Re: Comments on IRRC Number 3231 / Regulation #7-536: Air Quality Fee Schedule Amendments

# TECHNICAL SYSTEMS AUDIT OF THE PENNSYLVANIA DEPARTMENT OF ENVIRONMENTAL PROTECTION BUREAU OF AIR QUALITY 2015

Conducted by US EPA Region 3
Air Protection Division
Office of Air Monitoring and Analysis

Finding QA9: At the Erie site (AQS ID: 42-049-0003) Electronic files were disorganized on the

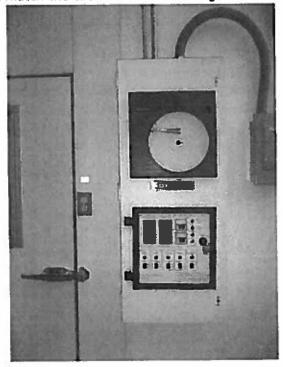
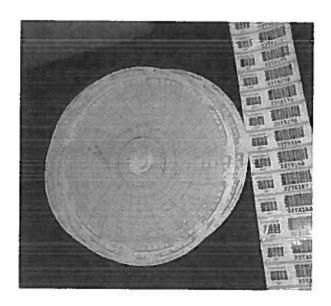
**Discussion:** The EPA audit team found no standard filing system for electronic records. QC and maintenance files were disorganized; the station operator couldn't produce all of the QC records at the time of the audit. Field staff save the QC and maintenance records on a central server but not all site operators retain a copy for their records.

- 1. Develop standard filename conventions and organize files into folders.
- 2. Update SOPs and QAPPs to include PADEP's electronic file system.

Finding LAB2: PM<sub>10</sub> filter weighing log had RH% above 45% that exceeded the weighing criteria.

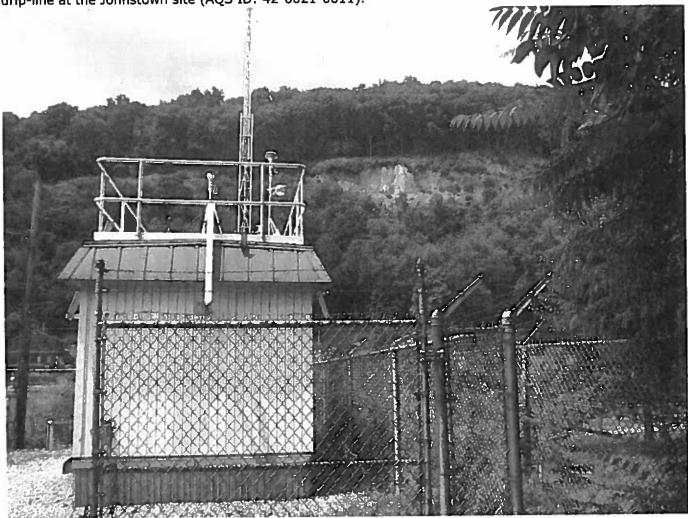
**Discussion:** The lab recorded humidity values above the acceptance criteria. There were no comments for values greater than 45% RH in the logbook. It's not clear if filters were weighed outside of the acceptance criteria. The  $PM_{10}$  filter conditioning requirement is a humidity range between 20% - 45% RH. Filters must be conditioned and weighed according 40 CFR 50 Appendix J Section 7

**Recommendation/Corrective Action:** Flag PM<sub>10</sub> data (in AQS) for the last three years where the weighed filters exceeded the humidity and/or temperature criteria using the QA code "1" (Deviation from a CFR/Critical Criteria Requirement).

**Finding FSE1:** Spacing from trees: BAM 1020 continuous PM<sub>2.5</sub> monitor is 7.62m (25ft.) from the tree drip-line at the Johnstown site (AQS ID: 42-0021-0011).

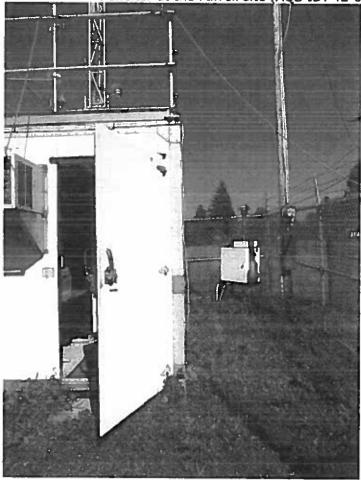
Discussion: PM2.5 inlets must be 10m from the dripline and should be greater than 20m from the dripline

when tree(s) act as an obstruction. 40 CFR part 58 Appendix E Table E-4.

Recommendation/Corrective Action: (1) The tree(s) must be removed or cutback or (2) the inlet

must be moved to adhere to the minimum requirements in Appendix E.

The operator of the Johnstown site received permission from the neighboring property owner to remove the large spruce tree that was within the drip line limits. A contractor provided a quote on 9/11/15 and DEP Purchasing approved the request. The removal of the tree was completed on October 28th 2015.

**Finding FSE3:** The Met One BAM 1020 inlet tube at the Washington site (AQS ID: 42-125-0020) was slightly angled and not perpendicular to the base of the instrument.

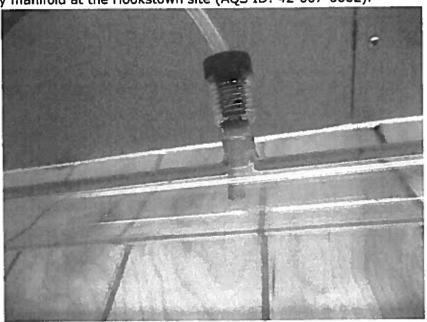
**Discussion:** "To achieve proper alignment, the BAM-1020 must be level, and the inlet tube must be absolutely vertical. This alignment is important to avoid transverse stress on the inlet as it enters the top of the BAM-1020. Stress may interfere with nozzle movement or cause air leaks at the BAM inlet." Standard Operating Procedure for the Continuous Measurement of Particulate Matter, Met One BAM-1020 PM<sub>2.5</sub> Federal Equivalent Method EQPM-0308-170 Section 9.5.1 page 9-7.

1. Straighten the inlet and downtube so that it's perpendicular to the base.

2. Review data and flag or invalidate data as appropriate.

Finding FSE4: Dirty manifold at the Hookstown site (AQS ID: 42-007-0002).

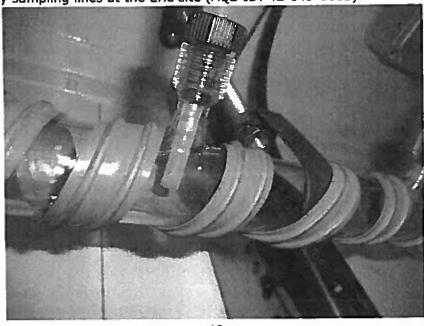
**Discussion:** Small insects and particles can accumulate inside of the tubing. This can cause blockage and affect the response of the instruments. In addition, particles can collect inside the tubing, especially at the entrance, thus affecting precursor gas concentrations.

**Recommendation/Corrective Action:** Clean the manifold. It's recommended that manifolds be cleaned every 6 months or sooner if needed.

Finding FSE5: Dirty sampling lines at the Erie site (AQS ID: 42-049-0003).

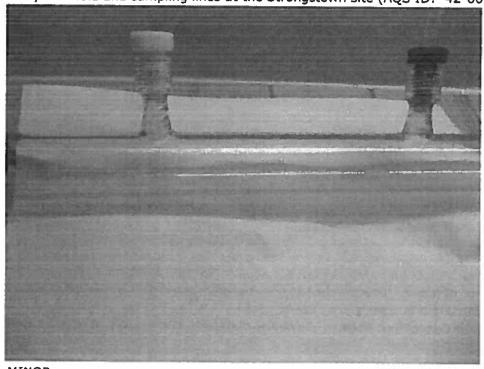
**Discussion:** Small insects and particles can accumulate inside of the tubing. This can cause blockage and affect the response of the instruments. In addition, particles can collect inside the tubing, especially at the entrance, thus affecting precursor gas concentrations.

Recommendation/Corrective Action: Replace dirty sampling lines.

Finding FSE6: Dirty manifold and sampling lines at the Strongstown site (AQS ID: 42-063-0004).

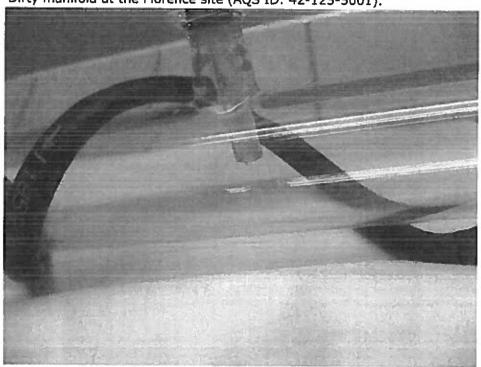
**Discussion:** Small insects and particles can accumulate inside of the tubing. This can cause blockage and affect the response of the instruments. In addition, particles can collect inside the tubing, especially at the entrance, thus affecting precursor gas concentrations.

**Recommendation/Corrective Action:** Clean the manifold and replace dirty sampling lines. It's recommended that manifolds be cleaned every 6 months or sooner if needed.

Finding FSE7: Meteorological tower less than 10 meters high at the Farrell site (AQS ID: 42-085-0100).

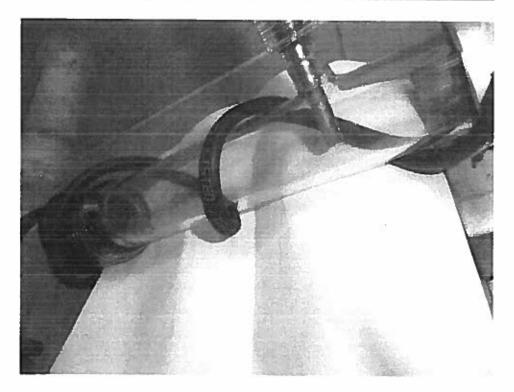
Discussion: "To accommodate wind speed/wind direction sensors, a meteorological tower must be able to reach a height of 10 m. The standard exposure of the wind instruments over level, open terrain is 10 meters above ground." References found in Quality Assurance Handbook for Air Pollution Measurement Systems Volume IV: Meteorological Measurements Version 2.0 (Final) 2008. Recommendation/Corrective Action: Raise tower to 10 meters.
